To: City Planning Commission
From: Planning and Urban Design Staff
Date: August 9, 2021
Re: Change of Zone Petition COZ2021-023

Requested Actions:
Change of Zone from C-1 Limited Business
and R-1 Single Family Districts to CP-2
Planned General Business District.

Purpose:
To build a convenience store/gas station and
gas canopy.

Property Location:
8919 Leavenworth Road

WEST ELEVATION
 SCALE 1/8" = 1'-0"

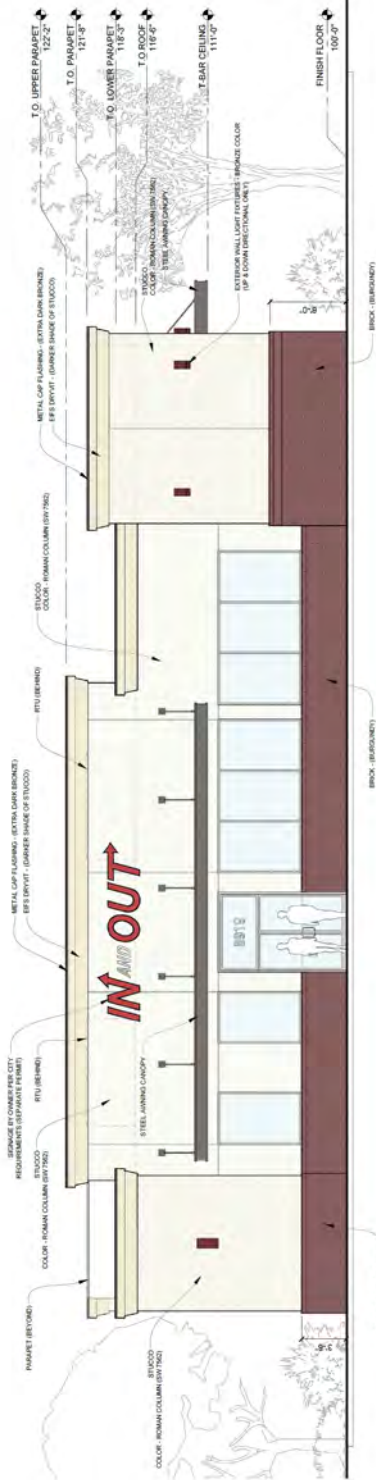
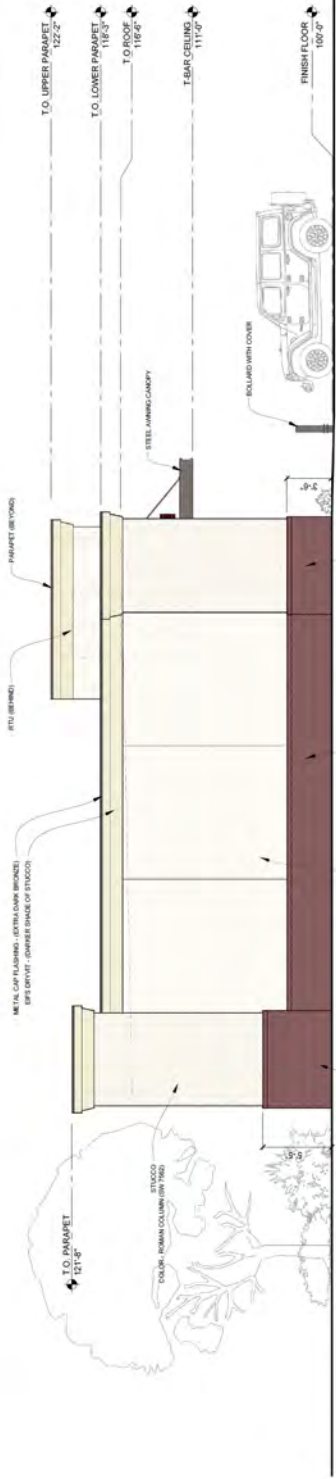
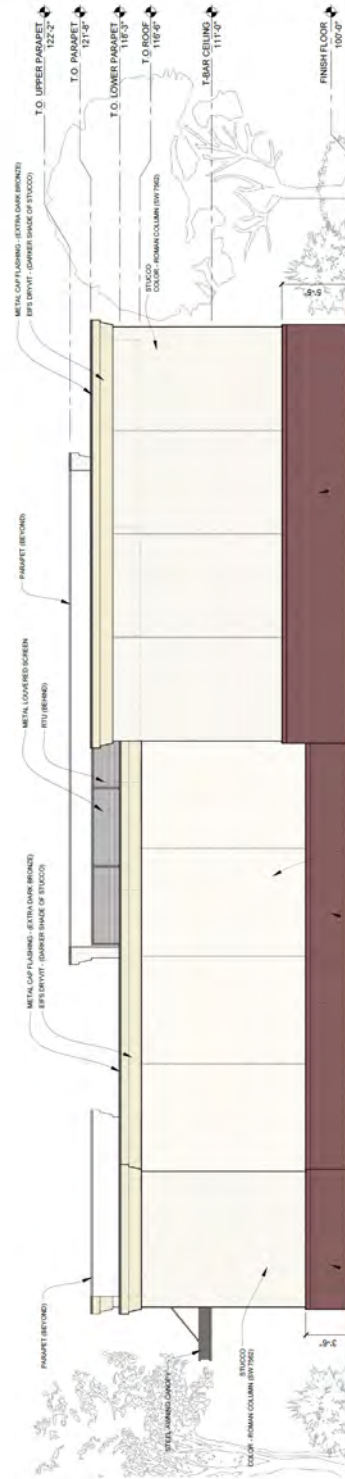
2. Sec. 27-576(c)(2) In order to break up the monotonous appearance of long facades, a building wall no more than forty-five (45) feet in length should be divided into increments of no more than forty-five (45) feet through the facades. This can be achieved through combinations of at least three (3) of the following techniques:
 - a. Divisions or breaks in materials;
 - b. Building offsets (projections, recess, niches);
 - c. Window bays;
 - d. Separate entrances and entry treatments; or
 - e. Variation in rooflines.

There is a separate entry on the west elevation and elevations indicate building offsets, although the site plan does not indicate articulation on the building. The elevations depict two (2) primary building materials, brick, and stucco.

Much of the building is true stucco, which is listed as an approved exterior building material, however, the intent of the guidelines is ensure that good design incorporates and combines design theme, building façade materials, colors, roof, and equipment.

Applicant Response: All four sides of the building will incorporate variations in approved materials, colors, rooflines, and building projects. The roof equipment will be screened on all four sides.
